Project: Stream Channel Stabilization

Location: 1701 West 100th Street – Harrison Park: Bloomington

Reviewer: BCO

Permit #: 2019-88
Project Name: Creek bank Stabilization in Harrison Park: Bloomington
Approval Date: August 21, 2019

STREAMBANK RESTORATION PROFILE

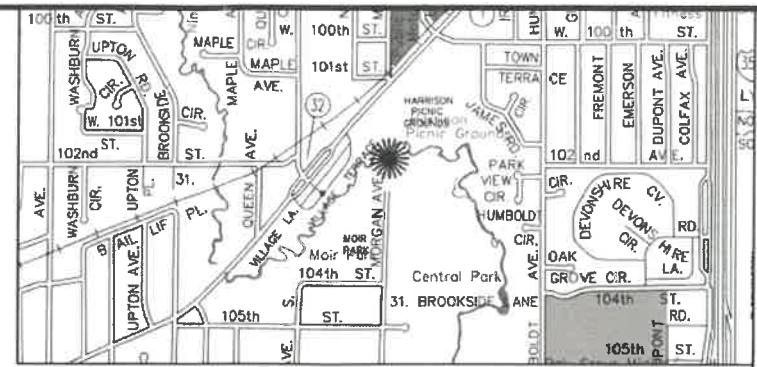
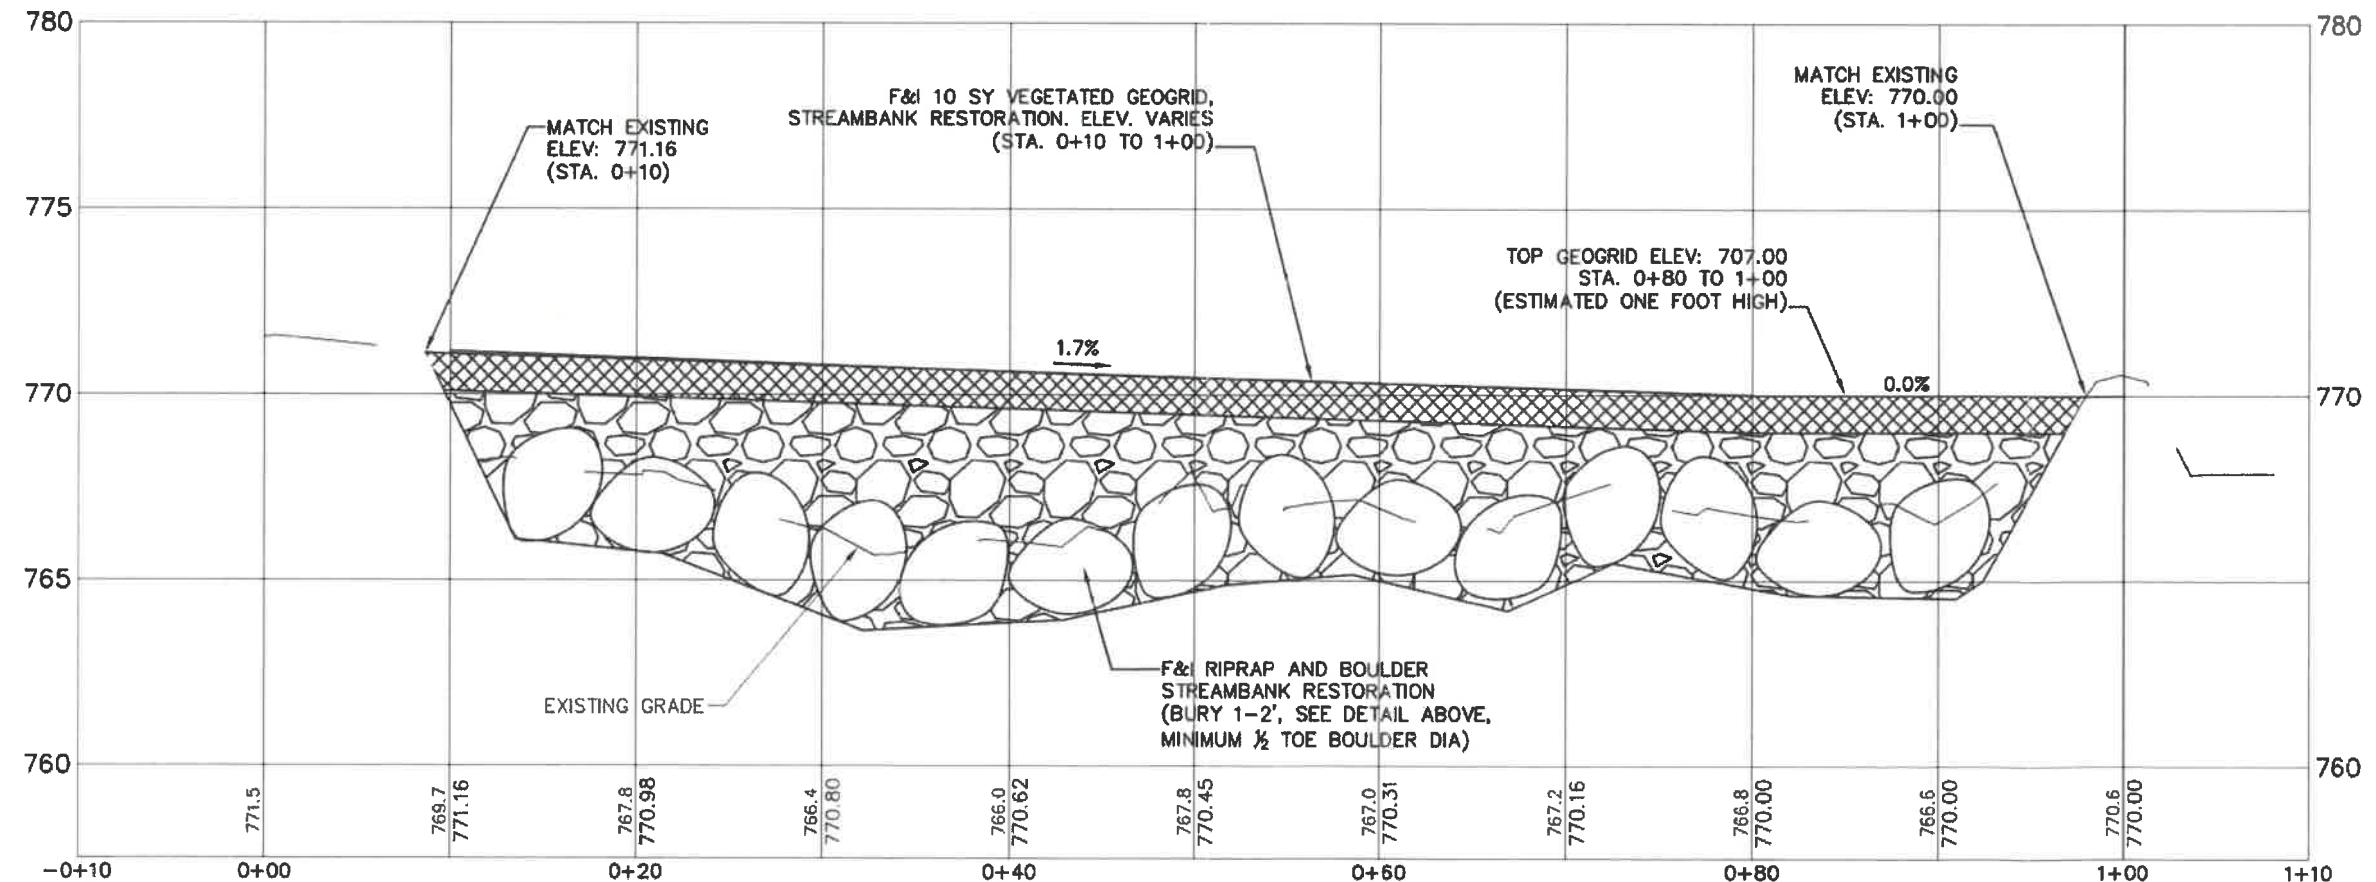
Filter material used will be 8-inches in depth complying with MnDot 3601. A North American Green C125BN geotextile filter fabric is to be used between the granular filter material and the native soil. The toe boulders are shown to be installed half buried below the normal level of the creek.

The plans show the stabilized channel banks at a slope of 3:1.
